PRODUCT: Breeders' Cup – Tournament Edition

BULLETIN: SB-009

ISSUE: Game gives away 1 Credit when Rebooted

DATE: 07-20-2005

Coin Comparitor Settings – Game gives away 1 Credit when Rebooted

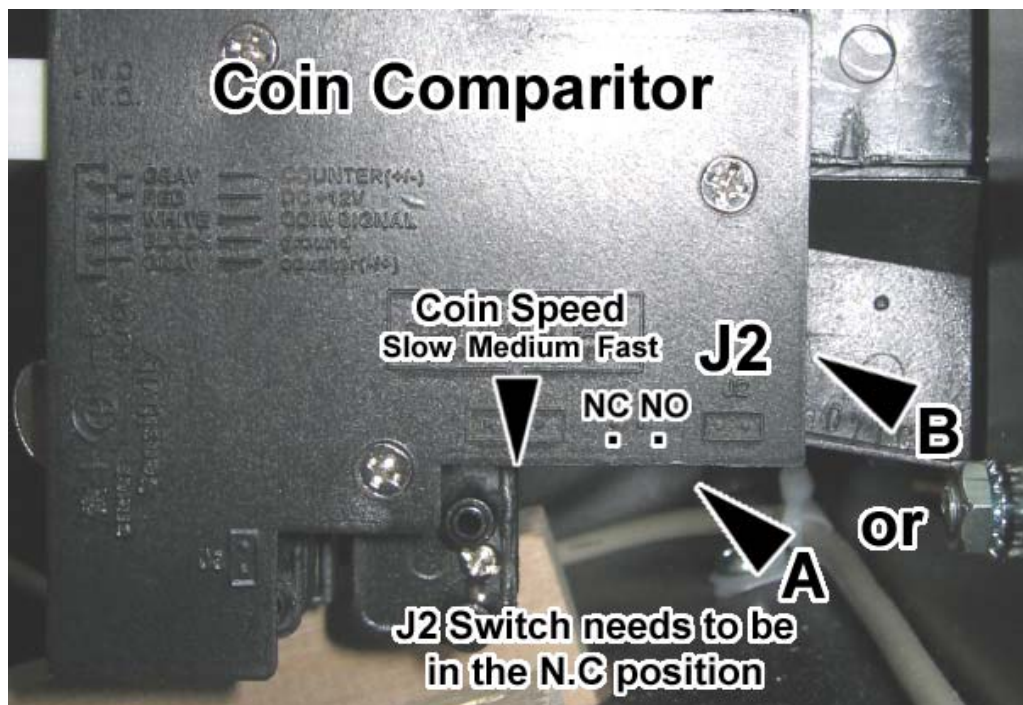
If you find that your Breeders Cup cabinet is giving away one credit when the cabinet is powered ON or rebooted then you need to adjust the J2 switch on the Coin Comparitor. There are 2 different switch located on the Coin Comparitor; the Coin Speed Switch has 3 setting, the J2 switch has only 2 settings please make sure you are adjusting the correct switch on the Coin Comparitor

Open up the cabinets control panel and on the left side of the Coin Comparitor are the instructions for the J2 Switch. The J2 Switch needs to be in the N.O or Normally Open position so the Coin Comparitor will not credit the cabinet when powered ON or rebooted. The J2 Switch can be found in 2 different spots A or B on the Coin Comparitor. When the J2 switch is located at position A the N.O switch position is towards the front of the cabinet. When the J2 switch is located at position B the N.C. switch position is towards the top of the cabinet. Adjust the J2 switch into the N.O. position on the Coin Comparitor and reboot the cabinet to verify the problem has been resolved.
